SUNDRY NOTICES AND REPORTS ON WELLS
Do not use this form for proposals to drill or to re-enter an abandoned well. Use form 3160-3 (APD) for such proposals.

Chevron respectfully requests to utilize a 5M system for the wells listed below, when drilling the production hole lateral drilling in the Wolfcamp formation.

Delaware Basin Changes to APD/COA for Federal Well

Summary of Changes to APD Submission

BLOWOUT PREVENTER SCHEMATIC

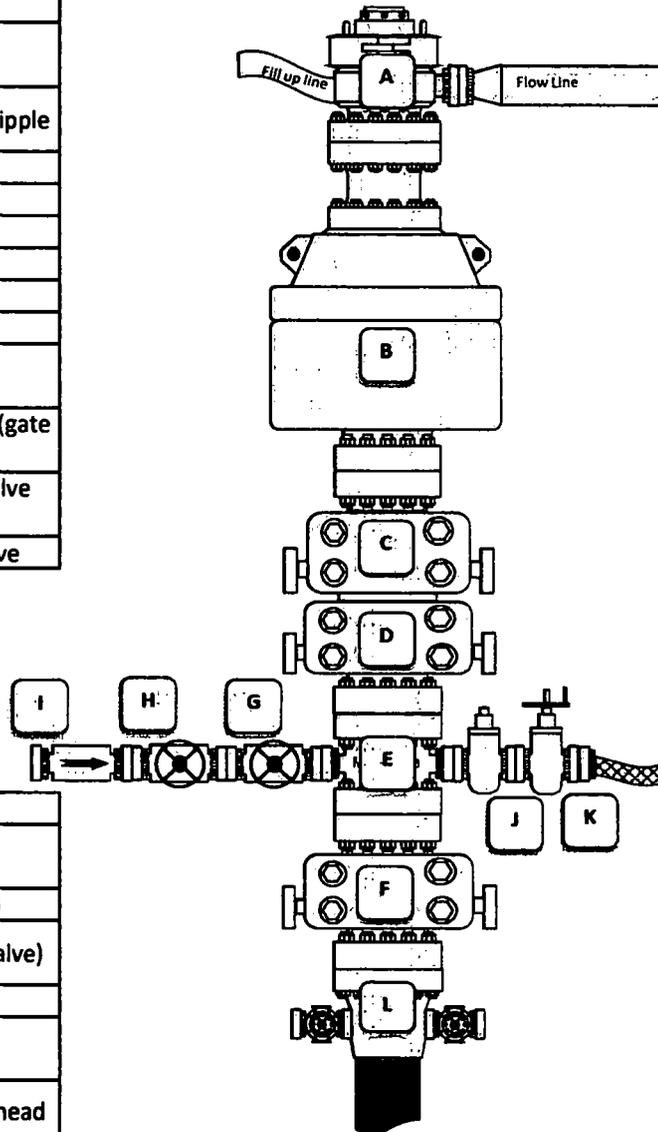
Chevron respectfully requests to utilize a 5M system for the wells named above, when drilling the production hole lateral drilling in the Wolfcamp formation.

The Class 4 BOP 5M BOP System (with upgraded 10M Stack/Choke manifold) and test pressures shall reflect as follows:

Component	Pressure – Low (PSI)	Pressure – High (PSI)
13 5/8" Annular	250-350	3500
3.5"x 5.5" or 4.5" x 7" VBRs or Rams	250-350	6650
3.5"x 5.5" or 4.5" x 7" VBRs or Rams	250-350	6650
Choke Manifold (valves)	250-350	6650

CHOKE MANIFOLD SCHEMATIC

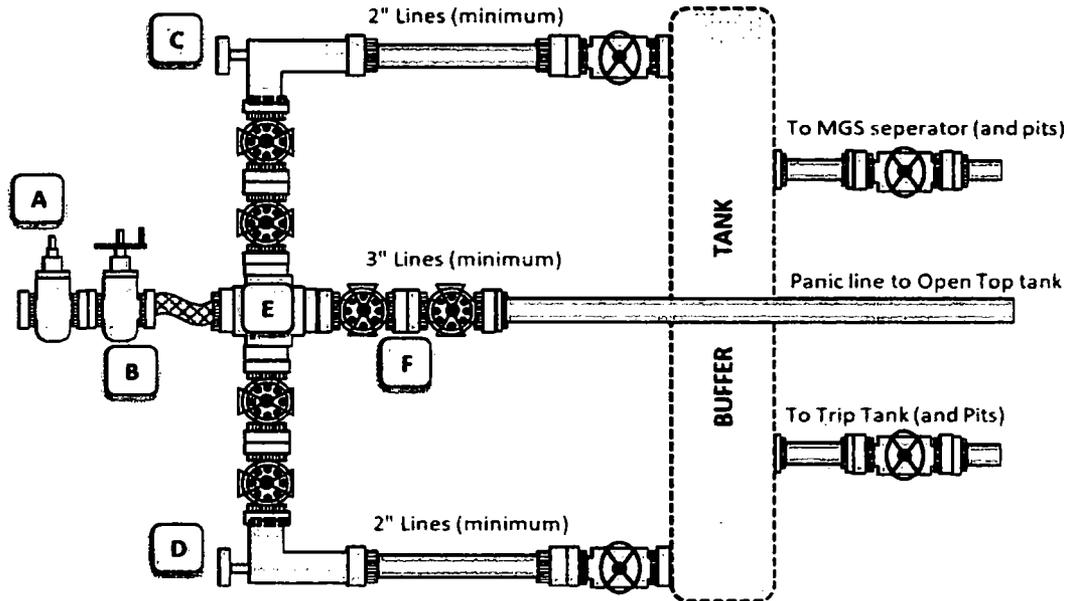
(Per onshore order 2, the 5M BOP/Choke Manifold Equipment stack will include 1x adjustable choke and 1x remotely operated choke.)
